## Product Change Notice (PCN)

PCN Number: **PCN-0450952R-01**

Product(s) Affected: **PJ-025**

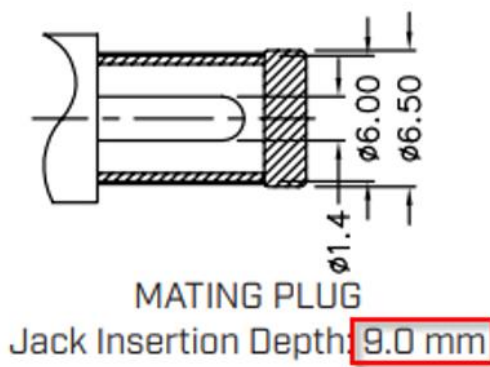
Description of Change: **Minor Housing and footprint differences. Material Change on the housing and terminals. See image Below**

PREVIOUS CUI DEVICES DETAIL / IMAGE			NEW CUI DEVICES DETAIL / IMAGE		
	MATERIAL	PLATING			
center pin	brass	tin	terminal 1	bronze t=0.50	silver
terminal 1	brass	tin	terminal 2	bronze t=0.25	silver
terminal 2	copper alloy	tin	terminal 3	brass t=0.40	silver
terminal 3	brass	tin	insulator	PA66 [UL94V-0]	black
plastic	PBT
